# **FC Endwall cart options comments**

Thomas Kutter,  
LSU

# Alternate Design

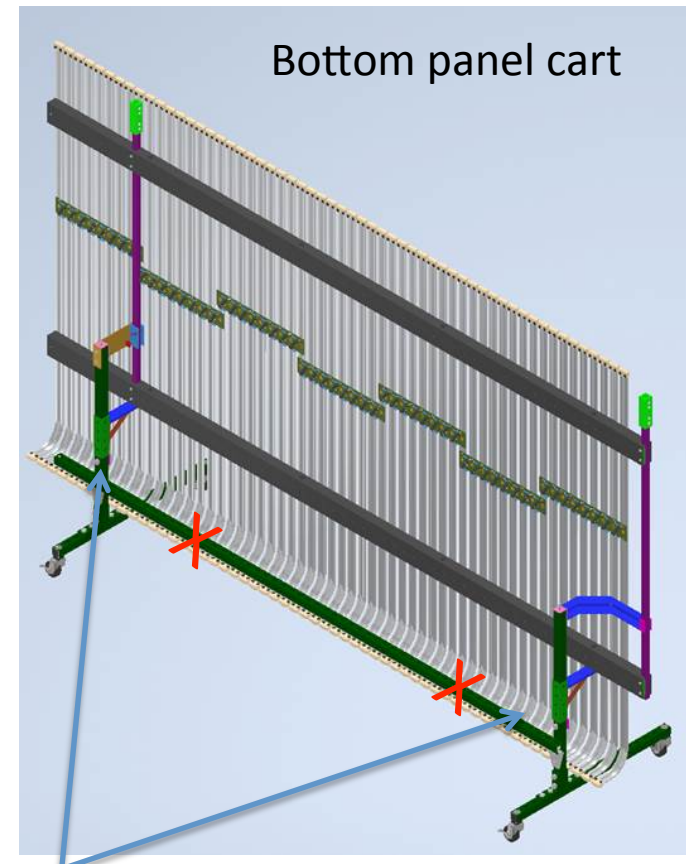
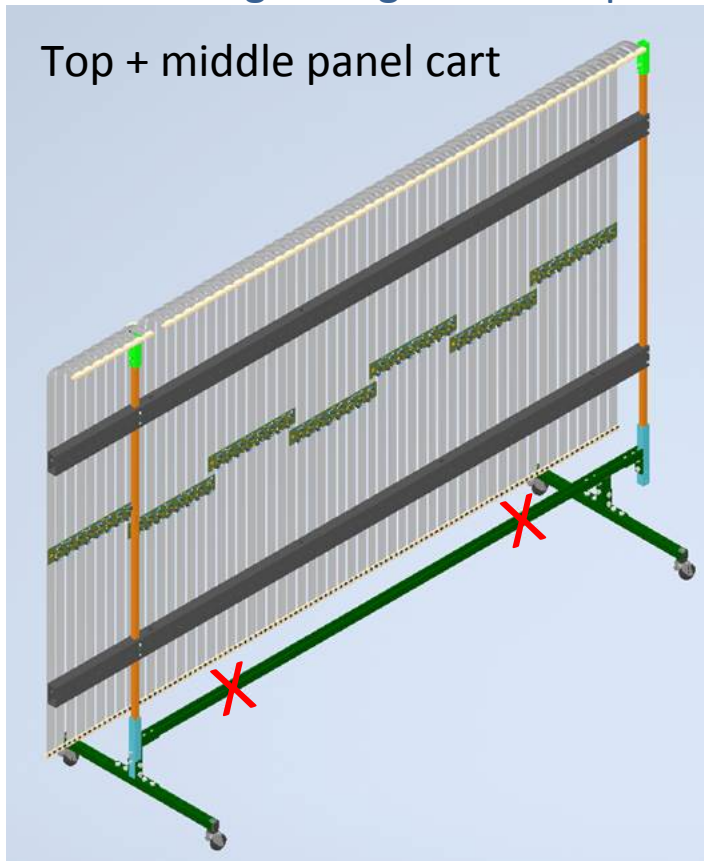
Motivation: avoid interference with APAs during installation → move wheels inwards

Comment: remove middle connection bar to keep carts more universal (5100 vs 5200), lightweight and simple

Height adjustable features

Comment/question: Why is height adjustment needed ?

Hanging panels are adjustable via winch/crane.

Probably don't need lower support features below FRP box beam (lower blue arm).
